**COMMENT RESPONSE MATRIX – JART (IN RESPONSE TO COMMENTS RECEIVED AUGUST 23, 2022, NOVEMBER 14, 2022 AND JUNE 1, 2023)**

UPPER'S QUARRY

DATE: August 25, 2023

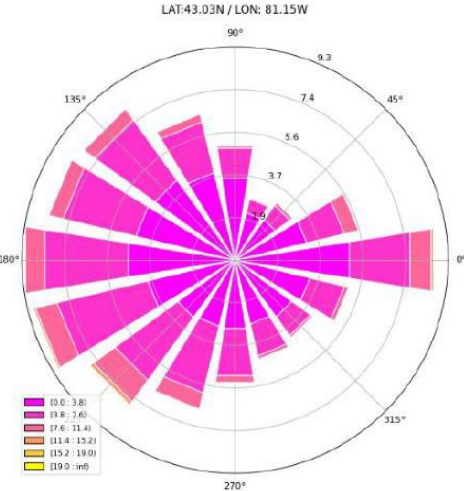
8.	Plantings should be placed on the 3m noise berms to provide a more attractive appearance.	MHBC (Nick M)	Agreed. The Visual Impact Assessment provides detailed recommendations for plantings and seeding of berms which are set out on the Site Plans and specifically Drawing 4 of 6 (Note G). Generally, the bottom third of the berms identified on the ARA Site Plans will be planted with some staggering to create a more natural look. The remaining portions of the berms will be seeded. Planting consists of a mix of naturalizing vegetation, allowing for fast growth in the short term and then a gradual natural succession to occur.

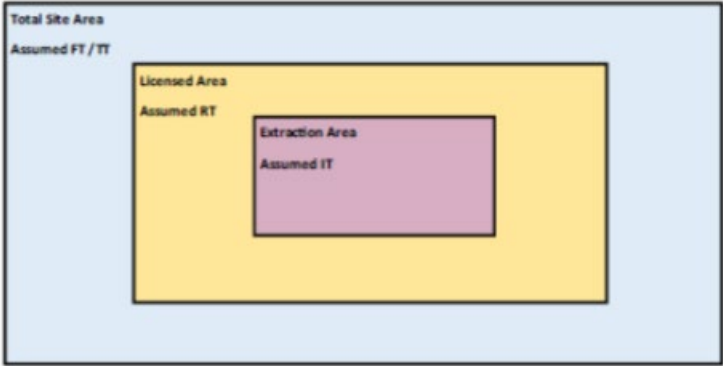
14.	If Upper's Lane is to remain a public road allowance, its existing 8.0 metre width will not be adequate to accommodate wider lanes for the expected truck use, and provide the required roadside features (shoulders, ditches, placement of utility poles, etc.). This will need to be evaluated through a detailed design of Uppers Lane. The City standard for a rural road is a minimum 20 metre right-of-way. Any additional road allowance width required will need to be dedicated to the municipality.	TMIG	Any improvements to Upper's Lane will be required for the sole purpose of the quarry and, accordingly, any road improvements along Upper's Lane needed to accommodate quarry traffic can be accommodated on Walker's lands and can be addressed through a future agreement with the City if the quarry is approved.
